TVA-BFN-TS-446

**BROWNS FERRY NUCLEAR PLANT (BFN) - UNIT 1 - TECHNICAL
SPECIFICATIONS (TS) CHANGE TS-446 - SAFETY LIMIT MINIMUM
CRITICAL POWER RATIO (SLMCPR) - CYCLE 8 OPERATION**

**GNF Additional Information Regarding the Requested
Changes to the Technical Specification SLMCPR**

Browns Ferry Unit 1 Cycle 8

Figure 1. Current Cycle Core Loading Diagram

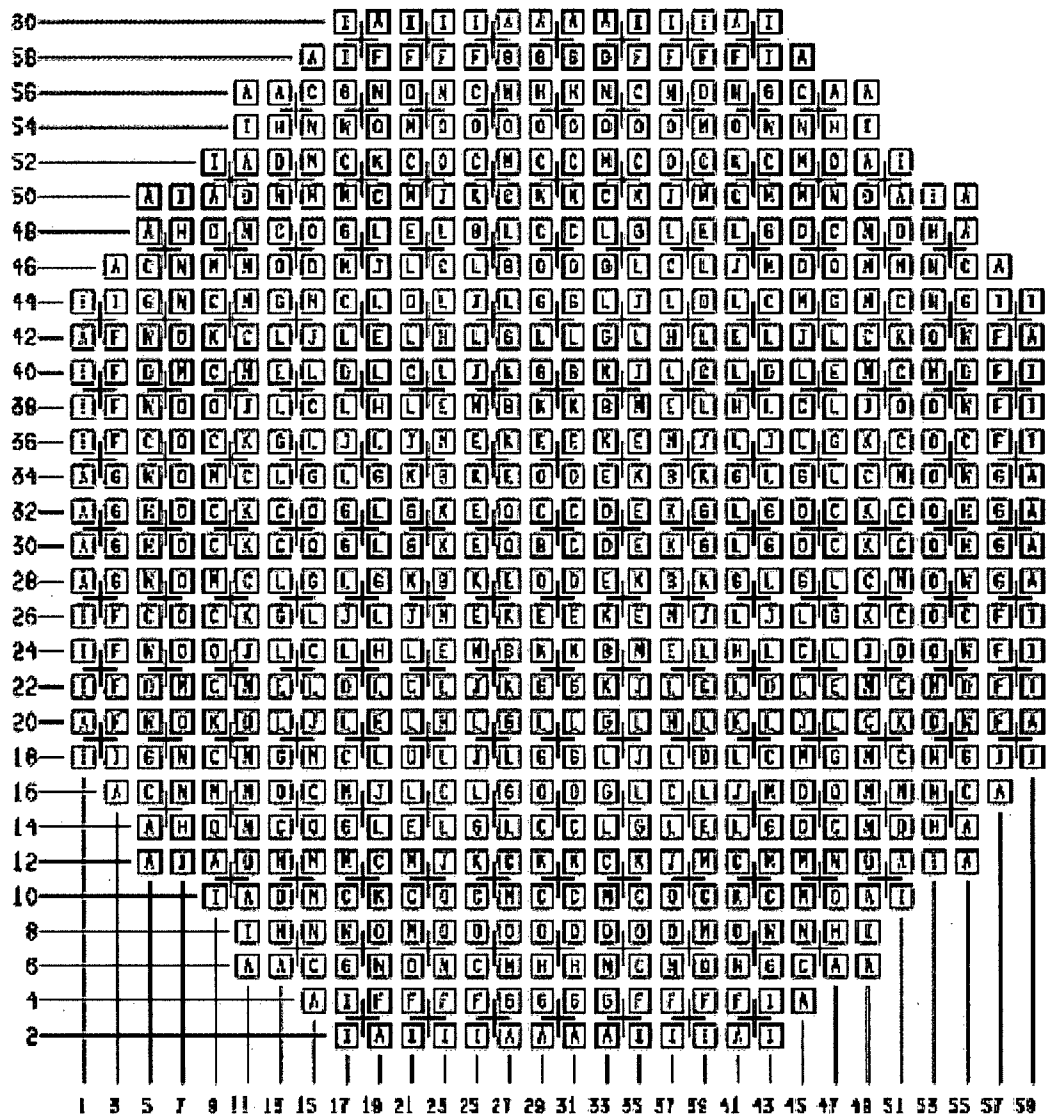
The Unit 1 Cycle 8 core is designed for Extended Power Uprate operation. The core design uses 328 fresh GE14 fuel assemblies, 108 irradiated GE13 fuel assemblies, and 328 irradiated GE14 fuel assemblies. The Unit 1 Cycle 8 core loading pattern is shown in Figure 1 of Enclosures 3 and 4.

Figures 1 and 2 provide the core loading diagram for the current and previous cycle respectively, which are the Reference Loading Pattern as defined by NEDE-24011-P-A. Table 1 provides a description of the core.
